## HISTORIC AND DESIGN REVIEW COMMISSION

February 01, 2017

**HDRC CASE NO:** 2017-027  
**ADDRESS:** 417 N OLIVE ST  
**LEGAL DESCRIPTION:** NCB 577 BLK 16 LOT A22 & A23  
**ZONING:** RM-4,H  
**CITY COUNCIL DIST.:** 2  
**DISTRICT:** Dignowity Hill Historic District  
**APPLICANT:** John Holzmann  
**OWNER:** Mod Olive LLC  
**TYPE OF WORK:** Fencing and the installation of a prefabricated home  
**REQUEST:**

# REAR 28' TINY HOUSE

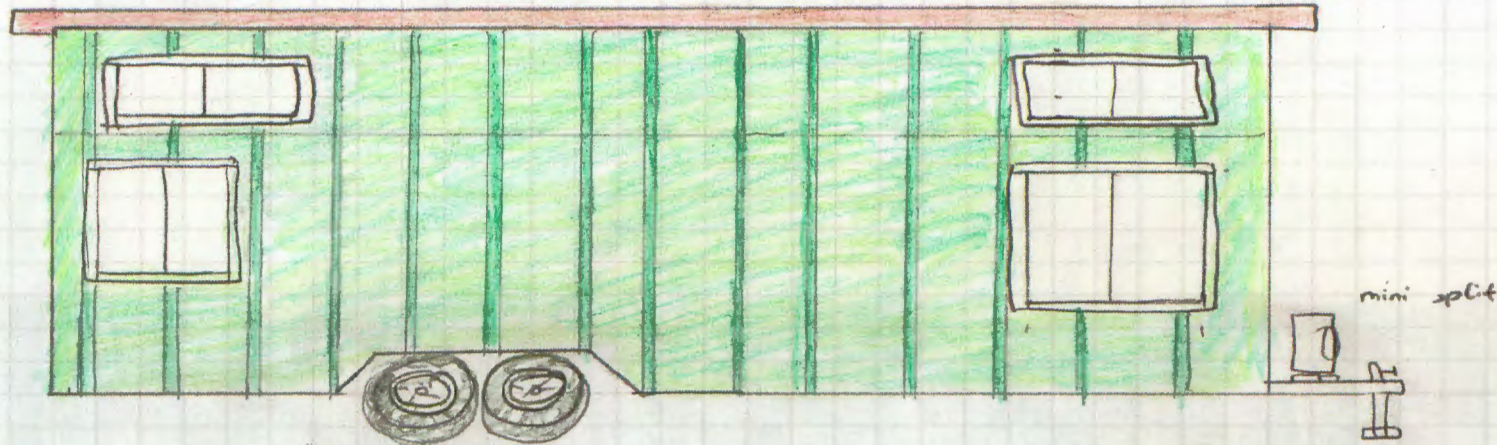
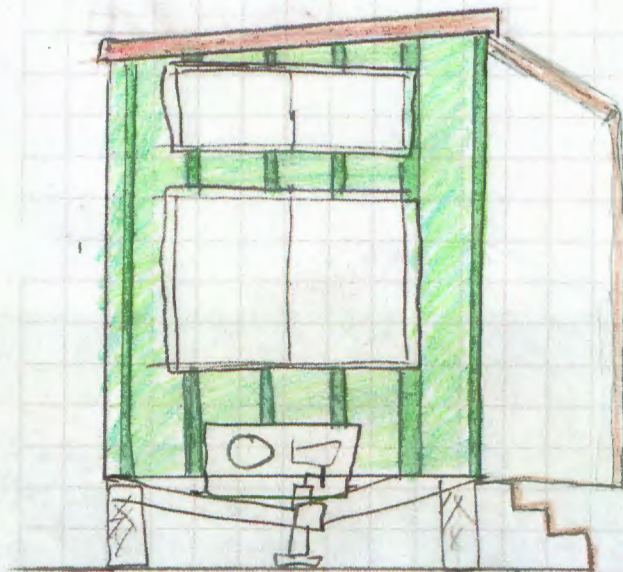
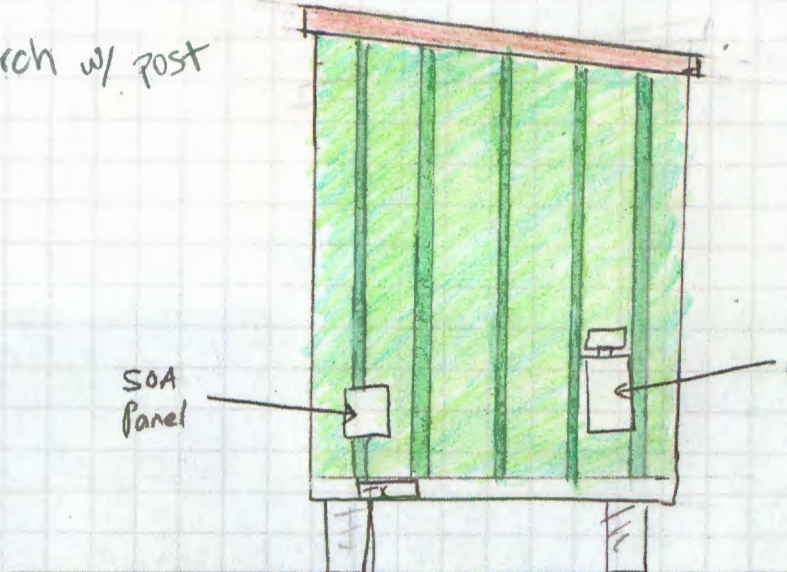
- c. **CHARACTER** – New accessory structures should relate to the primary historic structure on the lot in regards to materials and architectural details. The applicant has proposed materials that include board and batten wood siding, a covered wood porch deck and a shed roof featuring a copper color. Staff finds the proposed siding materials appropriate; however, the applicant should install roofing that features a galvalume or silver finish.

- d. **WINDOWS AND DOORS** – The applicant has proposed to install bronze colored low-e argon filled aluminum windows. The Guidelines for New Construction 5.A.iv. states that window and door openings should be similar to those found throughout the district. Staff finds the proposed window and door openings do not relate to historic window and door openings found on historic structures throughout the district.

Staff does not recommend approval of items #2 and #3 based on findings a through e and h. Staff finds that a prefabricated structure may be appropriate to locate on the lot during the construction of a primary structure that is consistent with the Guidelines and has received approval from the Historic and Design Review Commission or as an accessory structure behind a principle structure.
